Errata Sheet

Product Family: DL205 Remote Master/Remote Slave
D2-RMSM and D2-RSSS

Manual Number D2-REMIO-M

Revision and Date Original Ed., Rev. A; May 1998

Page 3-8. Step Four: Connecting the Wiring; Cabling Between the D2-250 CPU bottom port and slaves

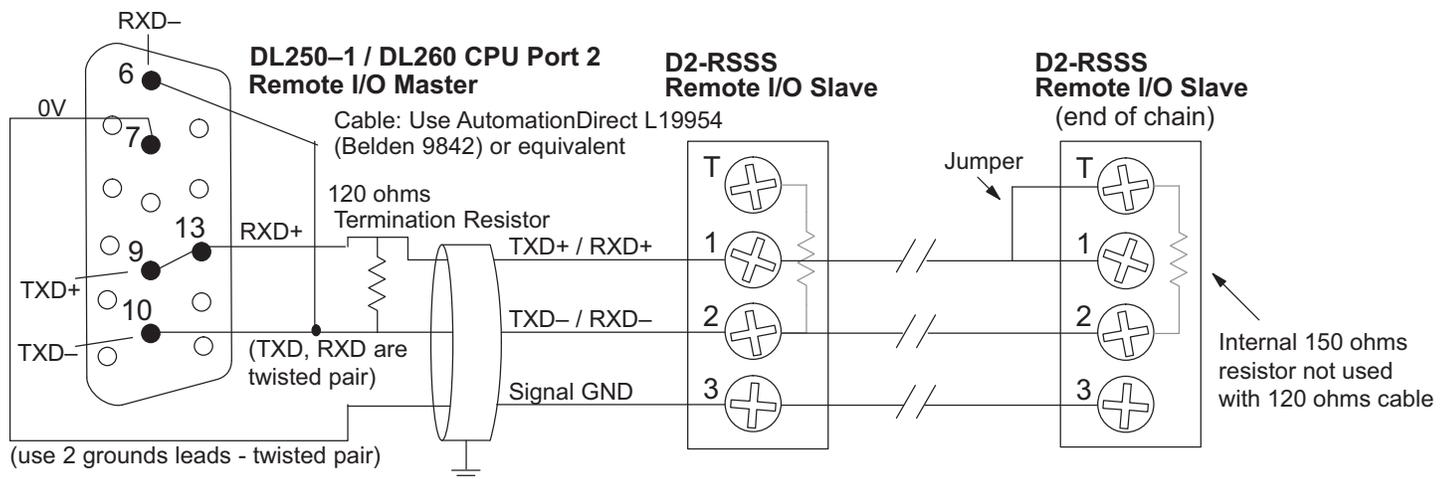
Replace the wiring drawing shown with this one:

Replace the paragraph right after this wiring drawing with this paragraph:

The twisted/shielded pair connects to the DL250-1 or DL260 Port 2 as shown. A termination resistor must be added externally to the CPU, as close as possible to the connector pins. Its purpose is to minimize electrical reflections that occur over long cables. A termination resistor must be present at both physical ends of the network.

Add the following note at the bottom of this page:

NOTE: To match termination resistance to AutomationDirect L19827 (Belden 9841), use a 120 ohm resistor across terminals 1 and 2.
